MONTGOMERY COUNTY HISTORIC PRESERVATION COMMISSION STAFF REPORT					
Address:	6124 MacArthur Boulevard, Bethesda	Meeting Date:	8/18/2021		
Resource:	Master Plan Site #35/47	<b>Report Date:</b>	8/11/2021		
A multicoute	( <i>Bonfield's Garage</i> ) William Fuchs	Public Notice:	8/4/2021		
Applicant:	(Christopher M. Ruhlen, Agent)	Tax Credit:	N/A		
<b>Review:</b>	Preliminary Consultation	Staff:	Michael Kyne		
Case Number:	N/A				
PROPOSAL:	After the fact tree removal, grading, site alterati	on, new hardscape co	nstruction

# **Preliminary Consultation**

The applicant proposes after the fact tree removal, grading, site alteration, new hardscape construction.

Updated Site Plan July 2021

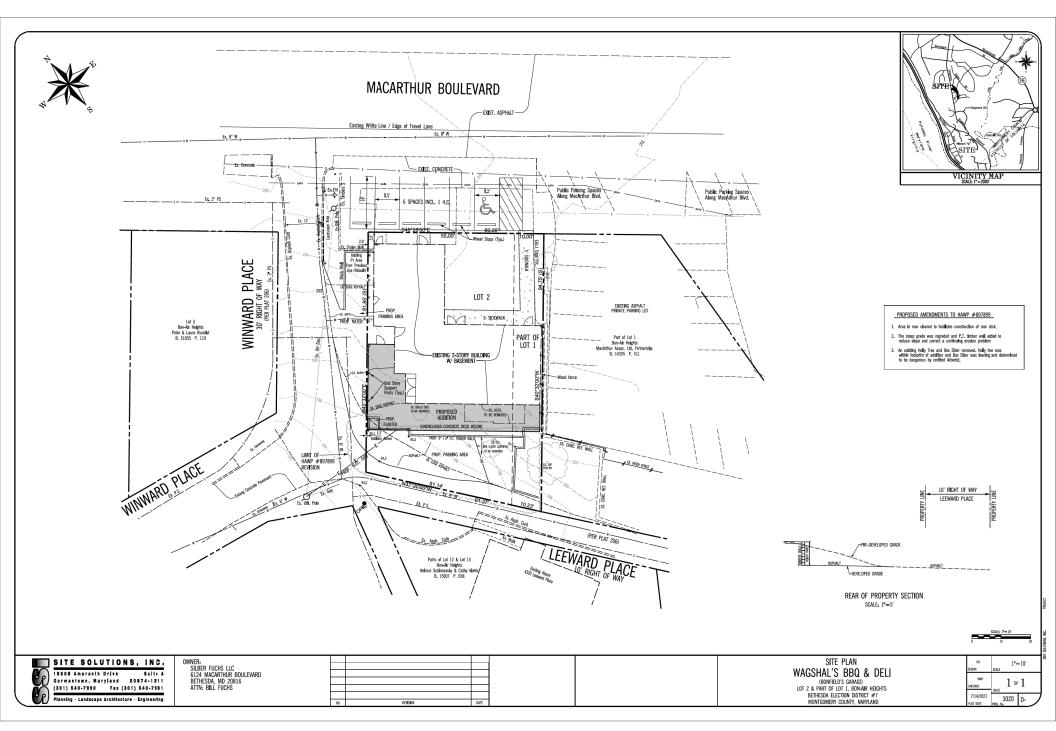
Staff is generally supportive of <u>a portion of</u> the applicant's proposal, given the hazardous condition of the

boxelder tree and the need to remove the existing vegetation and regrade the site to accommodate the previously approved new deck and associated utilities. However, staff finds that the proposed new retaining is incompatible with and detracts from the character defining features of the historic c. 1924 automobile garage, contrary to *Standards #2* and *#9*. Although the retaining wall is negligibly visible, at best, from the public right-of-way of MacArthur Boulevard, it is clearly visible from the public rights-of-way of Winward Place and Leeward Place.

Accordingly, staff recommends remediation of the retaining wall, which has already been constructed, and asks for the Commission's guidance regarding appropriate options. Remediation options include, but are not limited to:

- Returning the site and grade to its previous condition, as documented by staff's July 24, 2019 photographs (<u>https://montgomeryplanning.org/wp-content/uploads/2019/07/Photos-for-II.A-6124-MacArthur-Boulevard-Bethesda.pdf</u>).
- Reconstructing the retaining, using more appropriate materials (i.e., poured concrete, concrete block, or parged block).
- Applying an appropriate veneer or finish to the already constructed retaining wall, taking visual cues from the historic building.
- Plantings/landscaping in front of the retaining wall to help it blend into the existing environment.
